NLT Product Change Notice PCN Tracking Number: NLT-PP-6457

Type name
NL8048BC24-09
NL8048BC24-09D
NL8048BC24-12
NL8048BC24-12D

Example of the name plate label

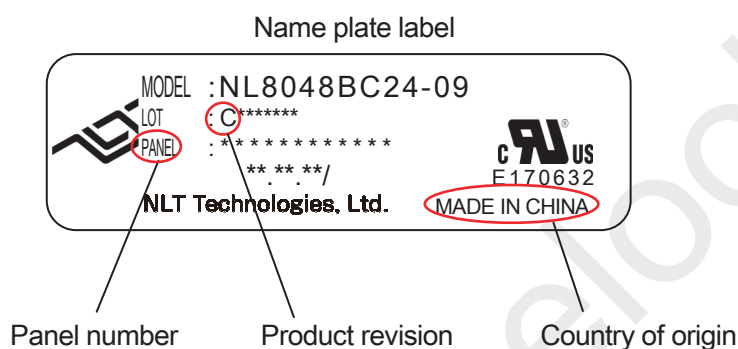
5. Nameplate label

Information of country of origin on the nameplate label will be changed as follows.

Country of origin	Current	After change
	MADE IN JAPAN	MADE IN CHINA

6. Internal control label and Marking-off line

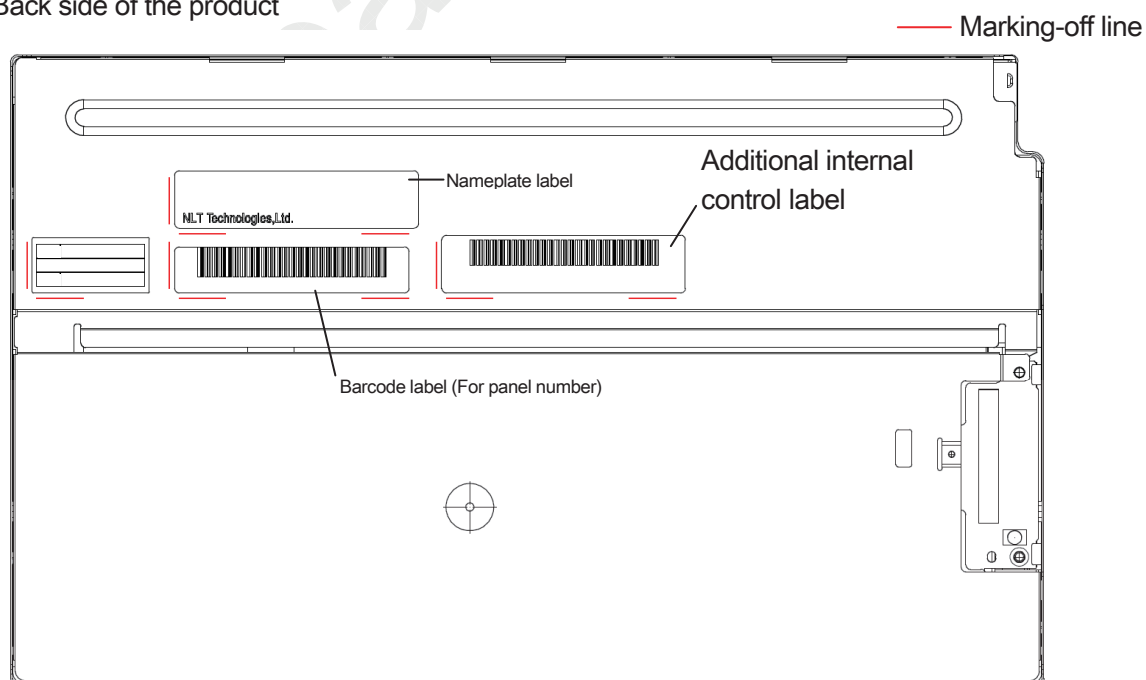
Internal control label	The internal control label will be added on the back side of the product. Please refer to page 3/3.
Marking-off line	Marking-off lines for reference of label attachment position will be added on the back side of the product.

NL8048BC24-09, 09D, 12, 12D
Back side of the product
